Model	Duplex Unit for N220 (Ricoh AD120, Savin Duplex Unit for 9180, Nashua DU3018, infotec Duplex Unit 9118)	Volt/Hz	Date of Modification	Serial Number
Modified Article	Parts Catalog			
Reason for Modification	Parts catalog correction

Model	Duplex Unit for N220 (Ricoh AD120, Savin Duplex Unit for 9180, Nashua DU3018, infotec Duplex Unit 9118)	Volt/Hz	Date of Modification	Serial Number
Modified Article	Parts Catalog			
Reason for Modification	Parts catalog correction

1. DUPLEX UNIT 1 (A491) (Page 2)

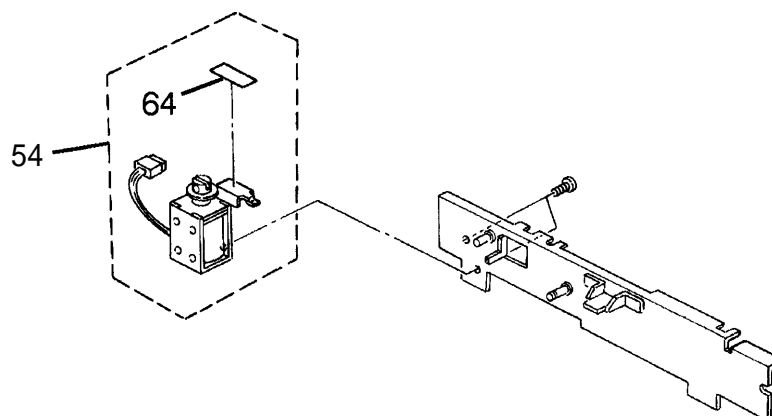
Please correct your parts catalog as follows:

Incorrect P/N	Correct P/N	Description	Q'ty Used	Index No.	Page
A4915220	A4914832	Fusing Gate Solenoid	1 - 1	54	3
	A4914831	Mylar Seal -0.188x9x33	0-1	#64	3

2. DUPLEX UNIT 2 (A491) (Page 4)

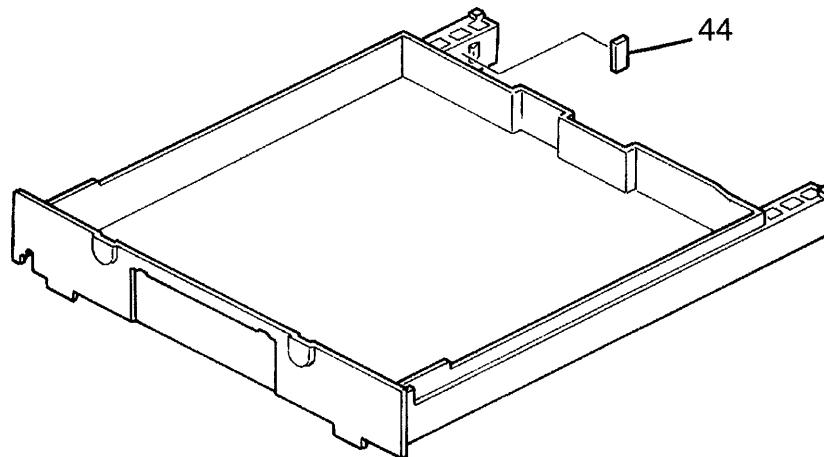
Please add the following part to your parts catalog:

Part Number	Description	Q'ty Used	Index No.	Page
AA162035	Cushion - Paper Tray	1	#44	5

Duplex Unit (A491) (Page 4)

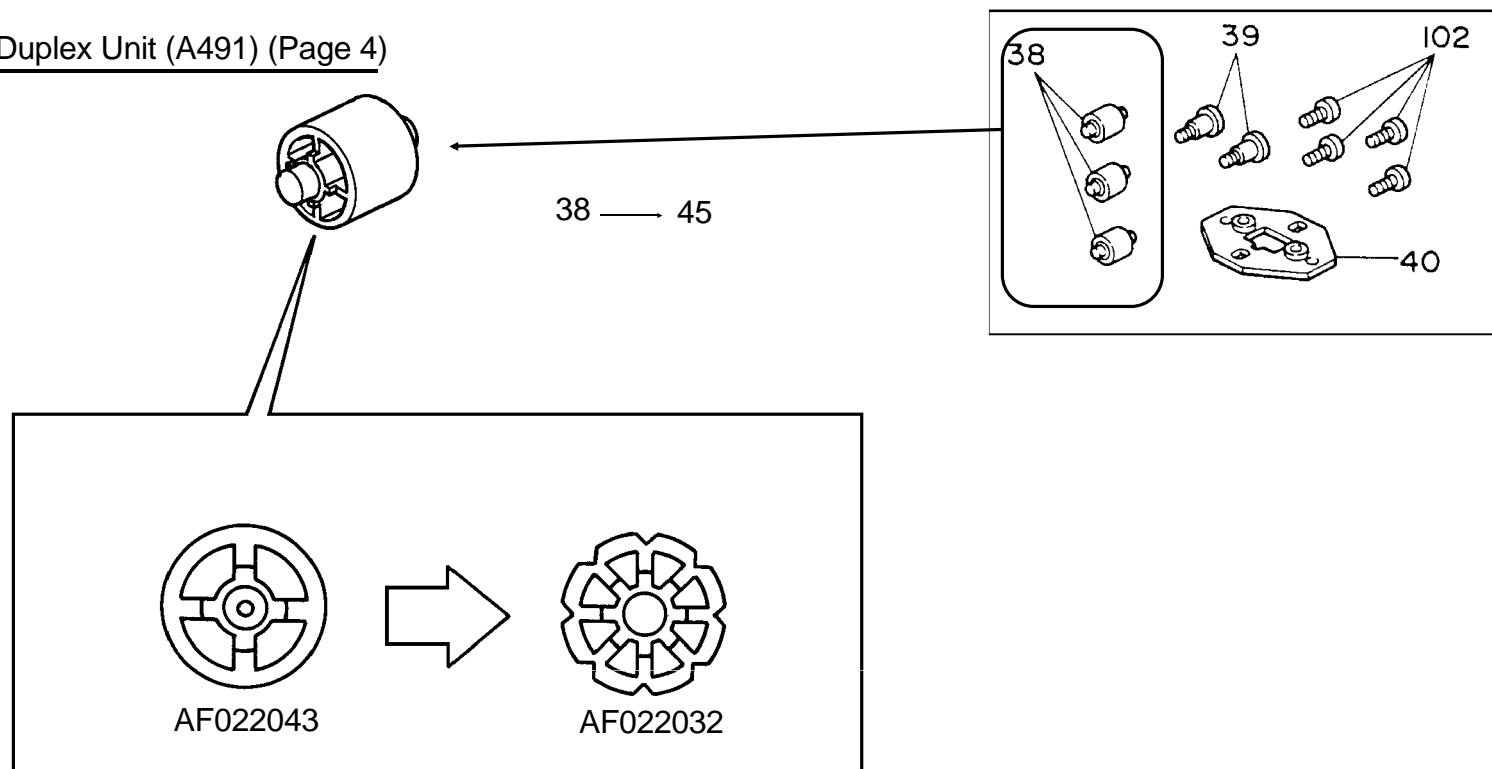
Model		Duplex Unit for N220 (Ricoh AD120, Savin Duplex Unit for 9180, Nashua DU3018, infotec Duplex Unit 9118)					Volt/Hz	Date of Modification	Serial Number	
Modified Article		Turn Driven Roller								
Reason for Modification		To prevent the center part of the paper leading edge from being folded								
Draw No.	Old Parts No.	New Parts No.	Description	A.B.C.	Q'ty Used Old → New	Inter- change- ability	Part needed for replacement by new part		Parts Catalog	
				Rank			Part No.	Description	Index No.	Page
	AF022043		Small Driven Roller		6 - 3				38	5
		AF022032	Turn Driven Roller		0 - 3	X/O			#45	5
								#: New Index

The center part of the paper leading edge is folded by hitting the turn driven roller when the paper curl is big.

To increase transportation of the roller, eight grooves have been given on the surface of the roller .

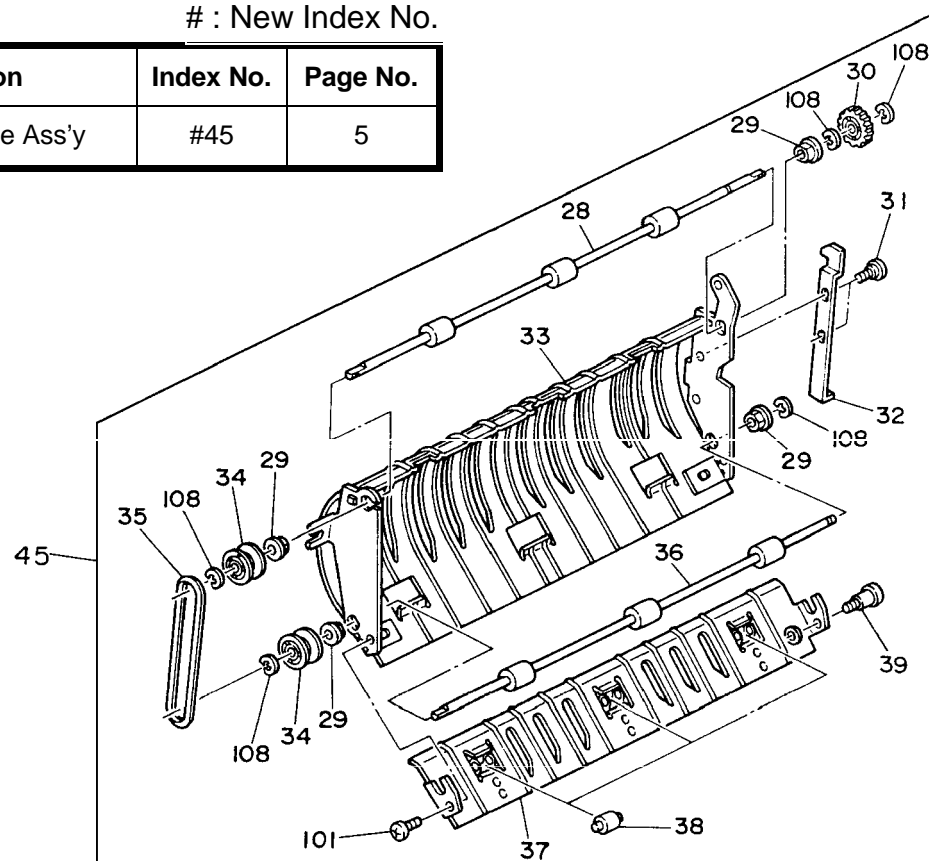
Model	Duplex Unit for N220 (Ricoh AL 200, Savin Duplex Unit for 9180, Nashua DU3018, infotec Duplex Unit 9118)	Volt/Hz	Date of Modification	Serial Number
Modified Article	Turn Guide Plate Ass'y			
Reason for Modification	To facilitate servicing

To facilitate servicing, the turn guide plate assembly (index number #45) has been registered as a service part as shown in the illustration.

Part Number	Description	Index No.	Page No.
A4914551	Turn Guide Plate Ass'y	#45	5

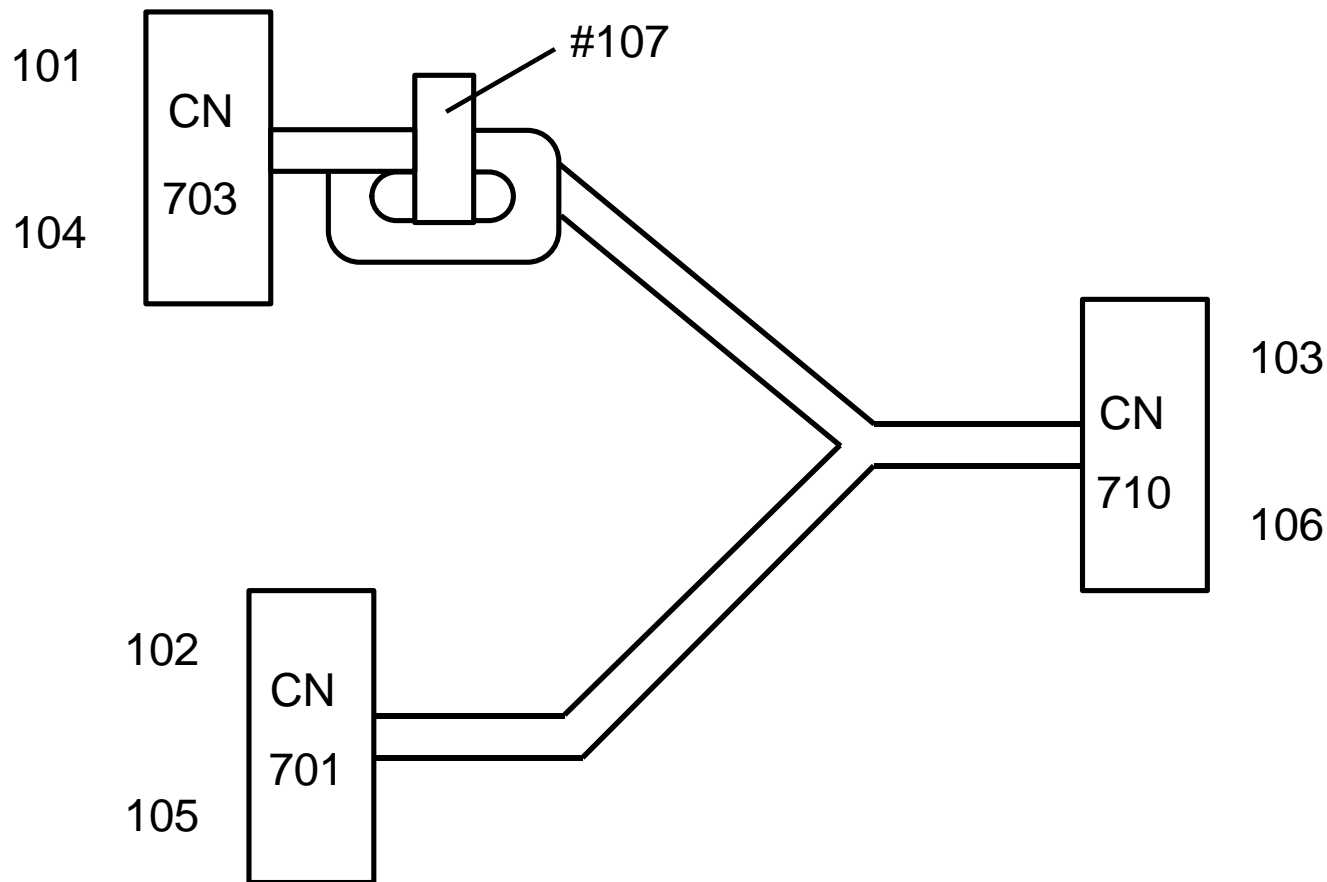
Model		Duplex Unit for N220 (Ricoh AD120, Savin Duplex Unit for 9180, Nashua DU3018, infotec Duplex Unit 9118)					Volt/Hz	Date of Modification	Serial Number	
Modified Article		Duplex Harness								
Reason for Modification		To reduce radio wave for Safety Standard (VDE)								
Draw No.	Old Parts No.	New Parts No.	Description	A.B.C.	Q'ty Used Old → New	Inter-changeability	Part needed for replacement by new part		Parts Catalog	
				Rank			Part No.	Description	Index No.	Page
	A4915300	A4915306	Duplex Harness		1 - 1	X/O			1	5
		16070272	Ferrite Core		0 - 1				#107	9
								# : New Index No.

A ferrite core has been added to the duplex harness as shown to reduce radio waves produced by the duplex unit.

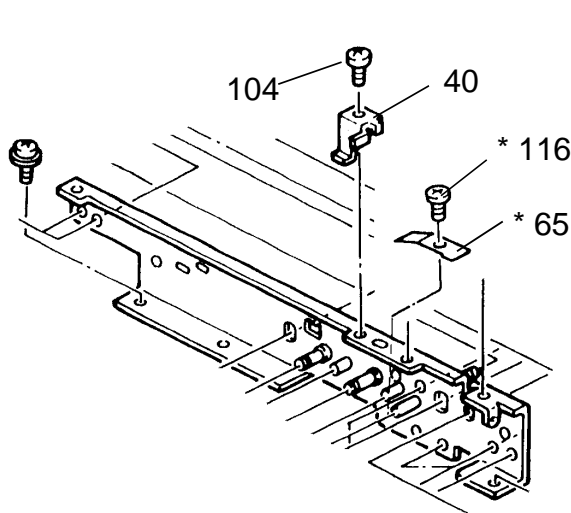
Model	Duplex Unit for N220 (Ricoh AD 120, SAVIN Duplex Unit for 9180, Nashua DU3018, infotec Duplex Unit 9118)	Volt/Hz	Date of Modification	Serial Number
Modified Article	Duplex Bottom Plate			
Reason for Modification	To ensure the grounding

To ensure the grounding to the duplex bottom plate, two sponge cushions has been added to the pressure plate and a spring plate has been added to the front side plate.

Old P/N	New P/N	Description	Q'ty Used	Inter-change-ability	Parts Catalog	
					Index No.	Page
A4914695	A4914694	Pressure Plate - Bottom Plate	1 → 1	X/O	17	5
	A3344672	Grounding Plate	0 → 1		* 65	3
	03130030B	Philips Pan Head Screw - M3 x 3	0 → 1		* 116	3

NOTE: A screw hole for the spring plate has been added to the front side plate. However, the part number of the front side plate has not been changed.

Sponge cushions has been added.

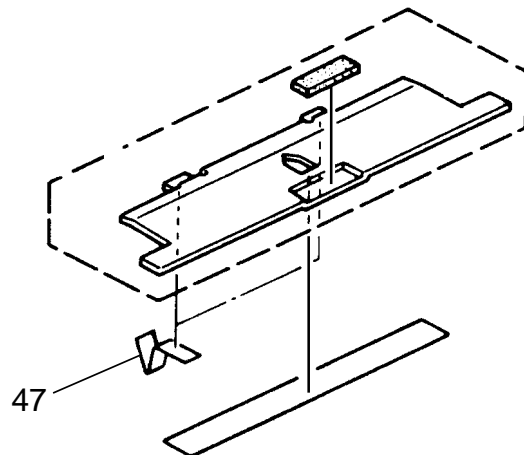
Model	Duplex Unit for N220 (Ricoh AD 120, SAVIN Duplex Unit for 9180, Nashua DU3018, infotec Duplex Unit 9118)	Volt/Hz	Date of Modification	Serial Number
Modified Article	Tray Bottom Plate			
Reason for Modification	To improve the bottom plate movement

To improve the bottom plate movement, two spring plate has been added.

Old P/N	New P/N	Description	Q'ty Used	Inter-change-ability	Parts Catalog	
					Index No.	Page
	A4914691	Spring Plate - Tray Bottom Plate	0 → 2		* 47	5

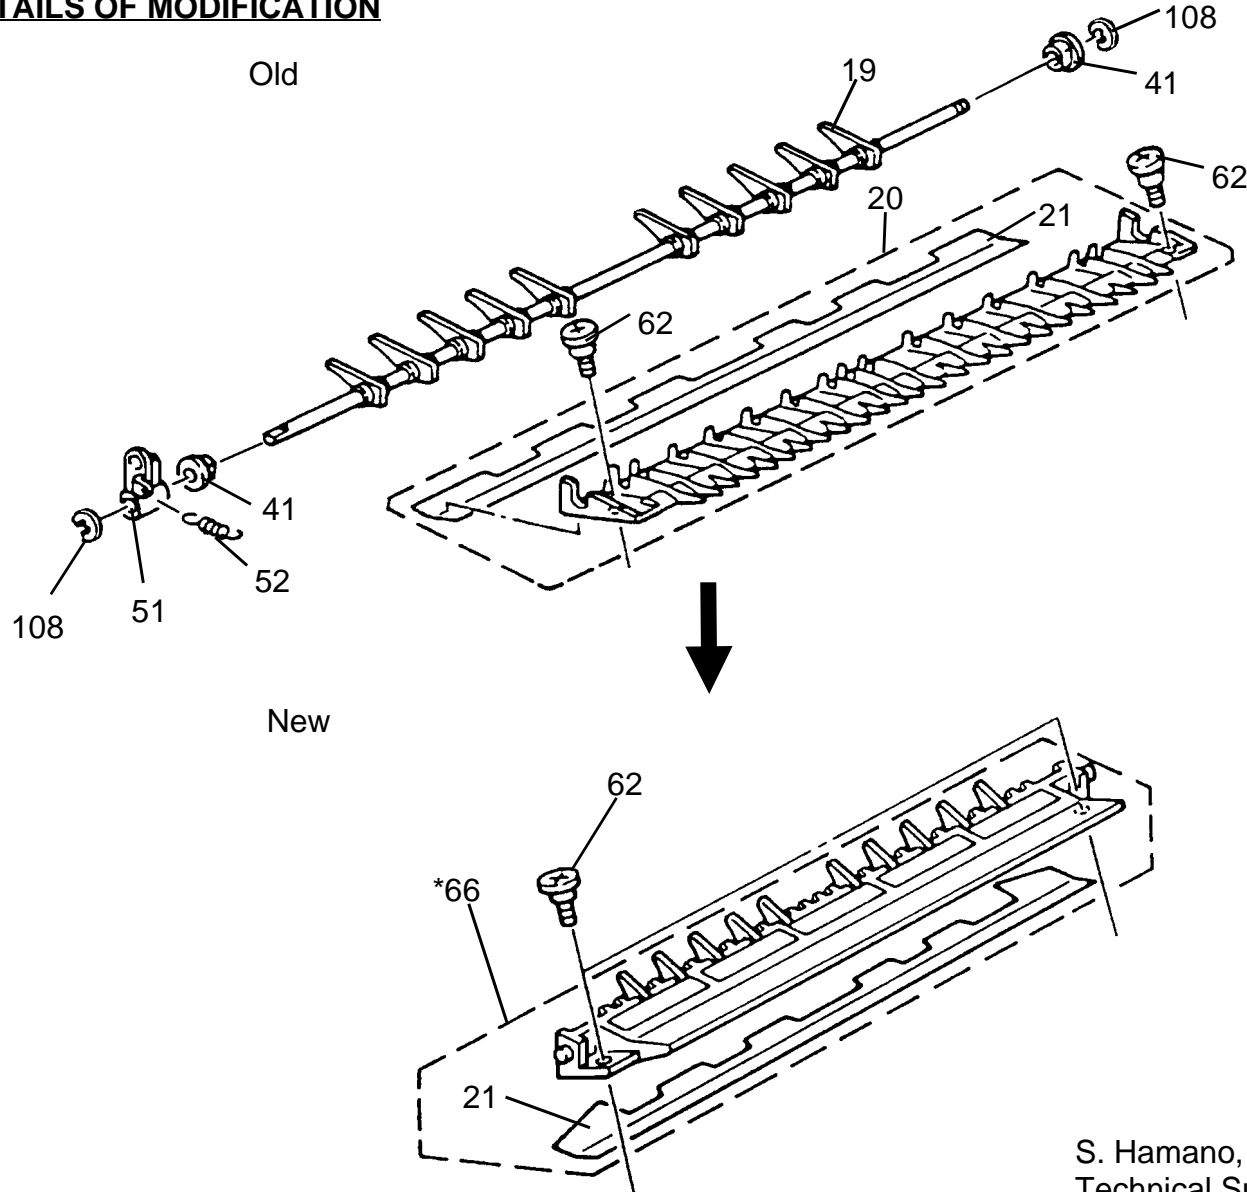
Model	Duplex Unit for N220	Volt/Hz	Date of Modification	Serial Number
Modified Article	Junction Gate, etc.			
Reason for Modification	Due to parts standardization with Pigeon Duplex

Due to parts standardization with the Pigeon Duplex, the inverter guide plate and junction gate have been become the one unit as shown in the next page.

Old P/N	New P/N	Description	Q'ty Used	Inter-change-ability	Parts Catalog	
					Index No.	Page
A4914789	A4914788	Inverter Guide Plate	1 → 0	X/	20	3
AA080022		Bushing - 4 x 7 x 5mm	4 → 2	X/	41	3
AF025013		Junction Gate	1 → 0	X/	19	3
A4914725		Junction Gate Hook	1 → 0	X/	51	3
54423233		Spring - Drive Wheel	2 → 1	X/	52	3
07200030E		Retaining Ring - M3	n → n-2	X/	108	3
		Inverter Guide Plate		/O	*66	3
